Item Name: QR Heli-Utility-Basket™, Short, HD Lid, Spacepod™ & Squirrel Cheek Comp., LH/RH

DART SERVICE INSTRUCTION

TO AMEND INSTALLATION INSTRUCTIONS D350-607-3 Rev.D,
INSTALLATION INSTRUCTIONS D350-607-4 Rev. C AND
INSTRUCTIONS FOR CONTINUED AIRWORTHINESS ICA-D350-607 REV. 6
REF TCCA STC: SH94-14
REF FAA STC: SR00213NY
REF EASA STC: EASA.10016996
REF BRAZILIAN STC: 2007S03-03/-04/-05/-06

FIGURE 1: INSTALLATION OF D4775-041 FWD STRUT

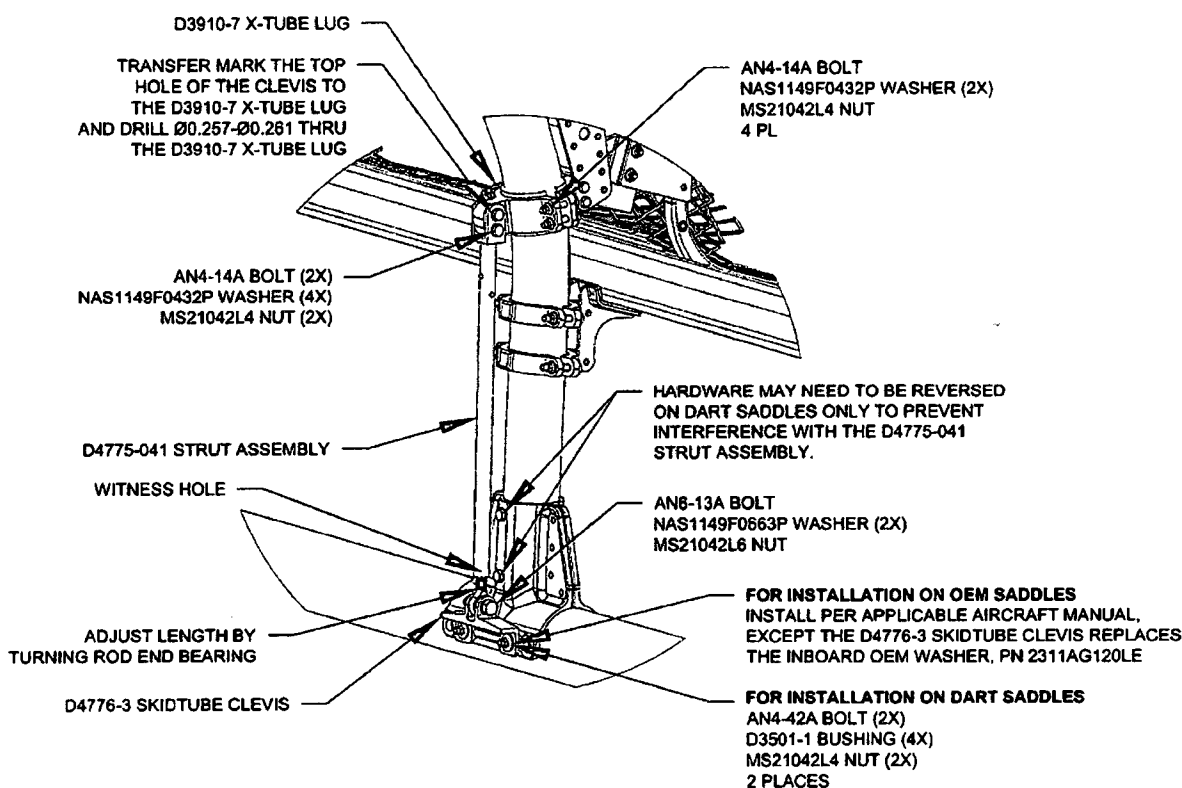
3.1 Substitute the Forward Lower D3910-5 X-Tube Lug with the D3910-7 X-Tube Lug as shown in Figure 1.

3.2 Install the forward D4775-041 Strut Assembly. Transfer mark from the upper hole on the clevis of the D4775-041 Strut Assembly to the D3910-7 X-tube Lug and drill thru the lug $\varnothing 0.257$ - $\varnothing 0.261$ as shown in Figure 1. Touch up chemical conversion coating per MIL-DTL-5541. Check the witness holes located at the bottom end of the D4775-041 Strut Assemblies to ensure that the thread from the rod end extends past the witness hole.
Torque MS21042L4/-4 nuts to 50-70 in-lbs (5.7-7.9 N-m). Torque MS21042L6/-6 nuts to 160-190 in-lbs (18.1-21.5 N-m).
